SKILLING, HELLE, CHRISTIANSEN, ROBERTSON
CONSULTING STRUCTURAL AND CIVIL ENGINEERS

DRAWING NO 13-K19 20.1

PROJECT NTC-1978 HOTEL - SUPPORT REV. | PROJECT NO 701.283 | BY WAB

ELEVATOR BUFFER BEAMS

PLAN EL. 294

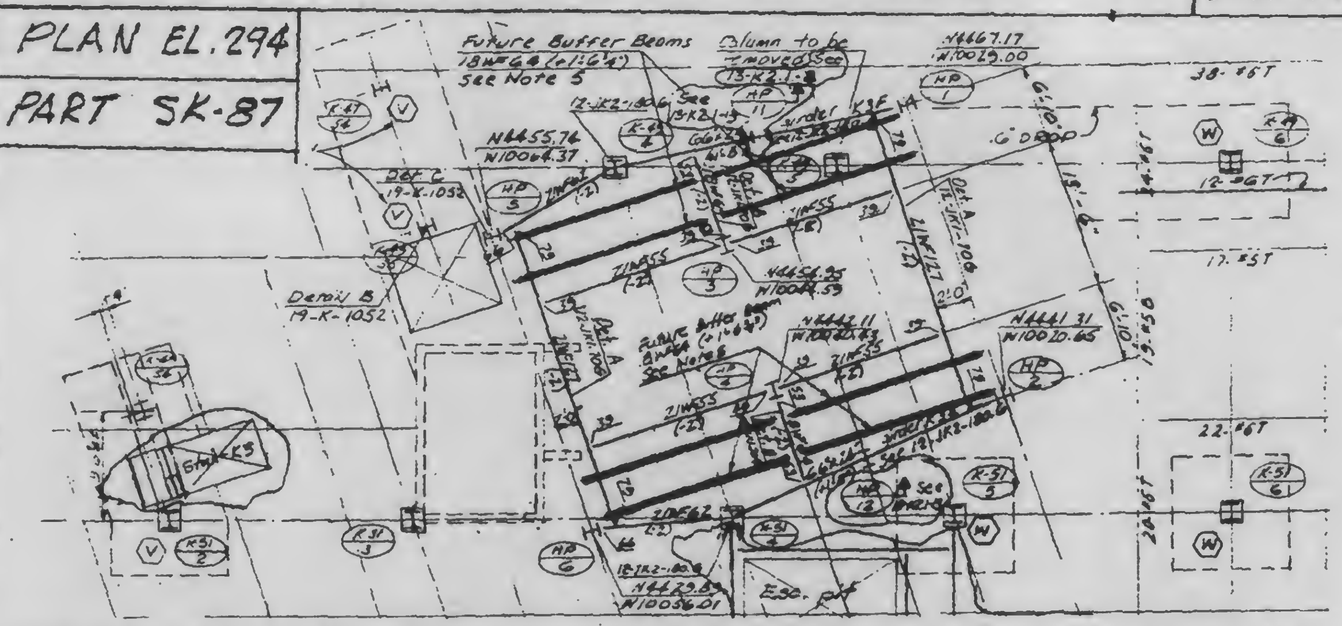
Note: 8 - Future Buffer Beams 18WF64 are now required. Provide W18x65 (±1'-6⅞") length and location in accordance with Approved Elevator shop Dwgs. See 19.20.2 (12.JK1-70G) for details of existing supports

PLAN EL. 284

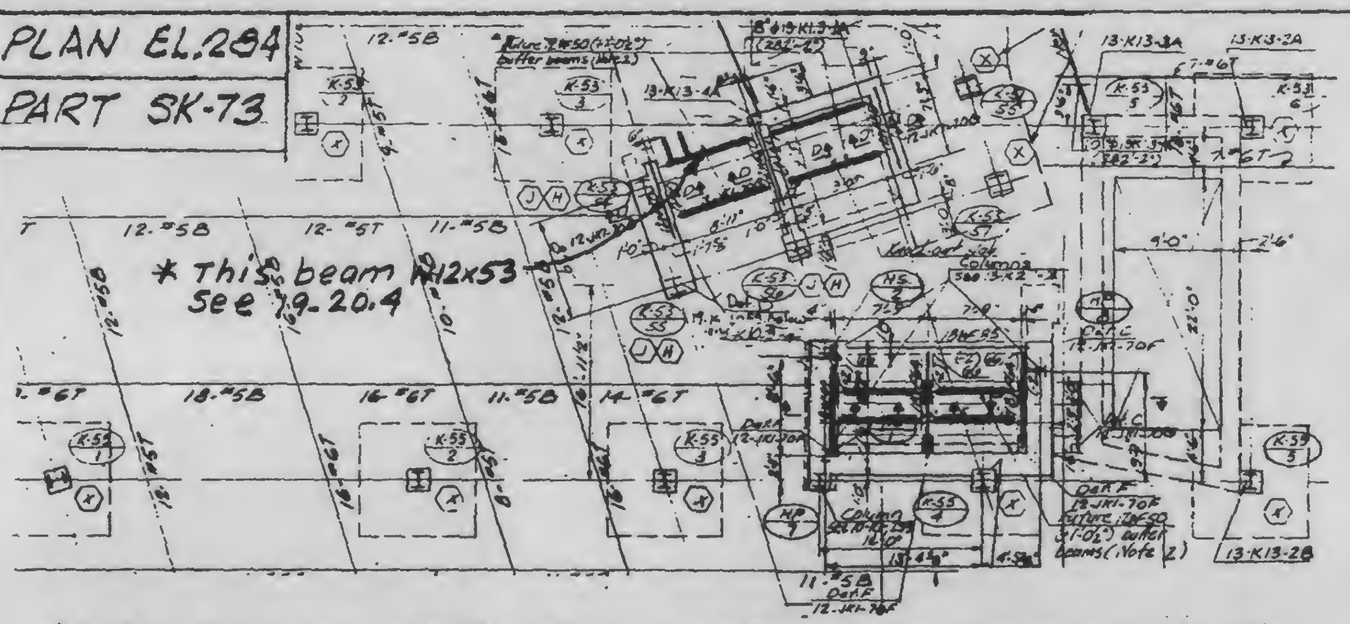
Note: 8-Future Buffer Beams 12WF50 are now required Provide W12x50 (±1'-0⅝") length and location in accordance with Approved Elevator shop Dwgs. Same for 2-Elevator Machine Beam shown on 19.20.4. See 19.20.3 (8.JK8-63.5) for plan of South Elevators and 19.20.2 (12.JK1-70G) for support details. See 19.20.4 (8.JK8-63.10) for plan of North Elevators and 19.20.5 (8.JK8-11) for support details
